## Urgent Medical Device Correction – 2955842-10/21/2013-010-C

Replacement of “Metal-finish” Lamp Modules on the da Vinci® Si™ (IS3000) System Illuminator

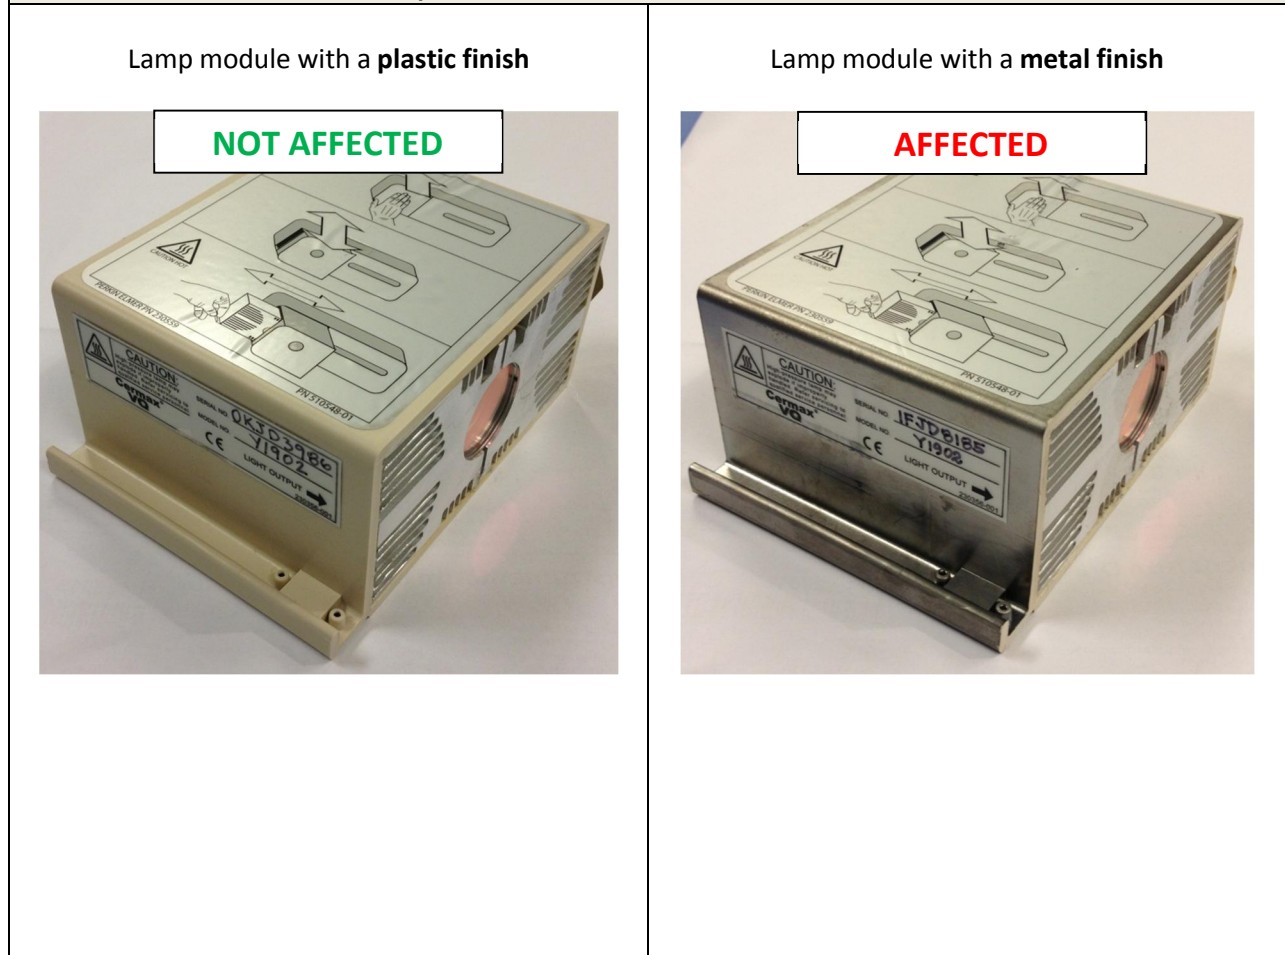
<b>To access the IS3000 HD Lamp Module:</b>	
<p>1. Unplug the light guide cable and press on the lamp module panel</p> 	<p>2. The panel will release, allowing access to the lamp module</p> 
<b>IS3000 HD Lamp Module Installed in the IS3000 HD Illuminator</b>	
<p>Lamp module with a <b>plastic finish</b></p> 	<p>Lamp module with a <b>metal finish</b></p>

Step	IS3000 HD Lamp Module installed in IS3000 HD Illuminator
1.	<p style="text-align: center;"><b>Metal finish</b></p>  <p>Remove the installed metal-finish lamp module and install a plastic-finish lamp module. If you need to order the plastic-finish replacement lamp module, go to Step 2.</p>
	<p style="text-align: center;"><b>Plastic finish</b></p>  <p>Continue to use the plastic-finish lamp module.</p>
	<p style="text-align: center;"><b>Firefly (Fluorescence) Illuminator</b></p>  <p>Continue to Step 3.</p>

**IS3000 HD Lamp Modules Not installed in the IS3000 HD Illuminator**

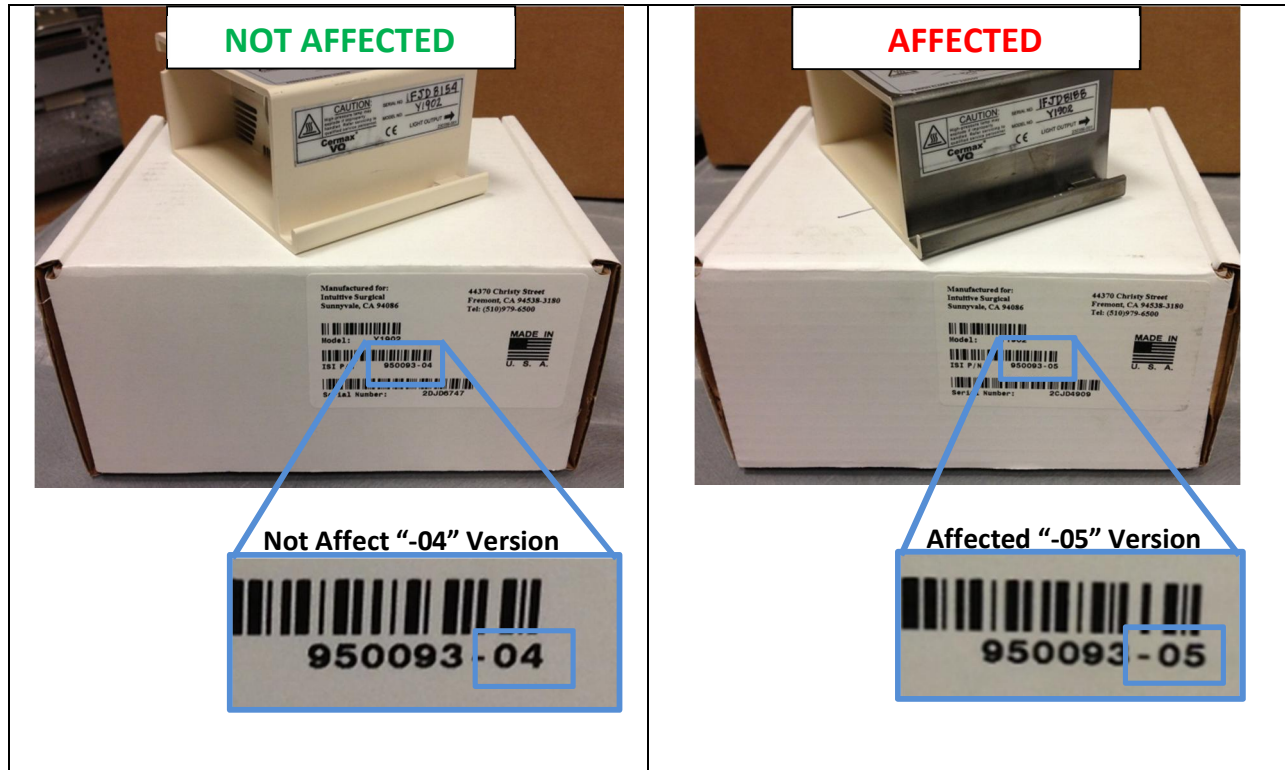
Identify whether you are in possession of the affected IS3000 HD Lamp Module:

- Examine the lamp module installed in the illuminator
- Examine your inventory of spare lamp modules

2.	<p>If needed, contact Intuitive Surgical Customer Service to order replacement (plastic-finish) lamp module(s). You may want to consider maintaining a replacement spare lamp module in your inventory.</p>

3.	<p>Return all metal-finish lamp module(s) in your possession via the Return Material Authorization (RMA) process to receive credit.</p>
4.	<p>Complete the Acknowledgment Form and return it to Intuitive Surgical as instructed.</p>
